[Docket No. FAA-2004-19960; Directorate Identifier 2004-CE-47-AD; Amendment 39-14153; AD 2005-13-16]

Airworthiness Directives; The New Piper Aircraft, Inc. PA-34 Series Airplanes

ACTION: Final rule.

Figure 1.

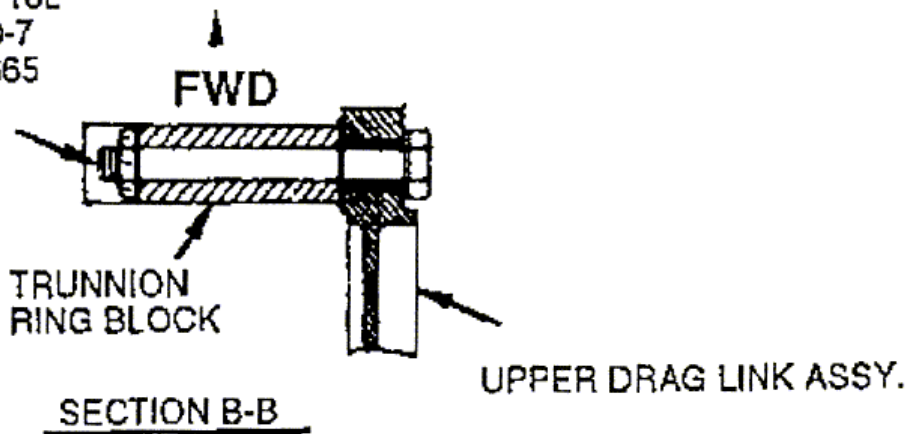
Actions	Compliance	Procedures
<p>(1) Replace the bolt and stack up that connects the upper drag link to the nose gear trunnion with new parts (or FAA-approved equivalent part numbers (P/N)) of the following:</p> <p>(i) Piper P/N 400 274 (AN7-35) bolt;</p> <p>(ii) Piper P/N 407 591 (AN960-716L) washer, as applicable;</p> <p>(iii) Piper P/N 407 568 (AN960-716);</p> <p>(iv) Piper P/N 404 396 (AN320-7) nut; and</p> <p>(v) Piper P/N 424 085 cotter pin.</p>	<p>Within the next 100 hours time-in-service (TIS) after January 28, 1994 (the effective date of AD 93-24-14), unless already done within the last 400 hours TIS before January 28, 1994 (compliance with AD 93-24-14). Repetitively replace thereafter at intervals not to exceed 500 hours TIS. Continue to repetitively replace until the actions in paragraphs (e)(2) and (e)(3) of this AD begin.</p>	<p>Follow Figure 1 of this AD.</p>
<p>(2) Do the inspections, replacements, and other corrective actions specified in Table 1 “Specified Maintenance” of Piper Service Bulletin No. 1123A, dated November 30, 2004.</p>	<p>Within the next 100 hours TIS after August 8, 2005 (the effective date of this AD), unless already done. Repetitively inspect thereafter at the intervals referenced in the Inspection Time column of the <i>INSTRUCTIONS</i> paragraph in Piper Service Bulletin No. 1123A, dated November 30, 2004.</p>	<p>Follow The New Piper Aircraft, Inc. Service Bulletin No. 1123A, dated November 30, 2004.</p>

AN7-35
AN960-716
OR
AN960-716L
AN320-7
MS24665
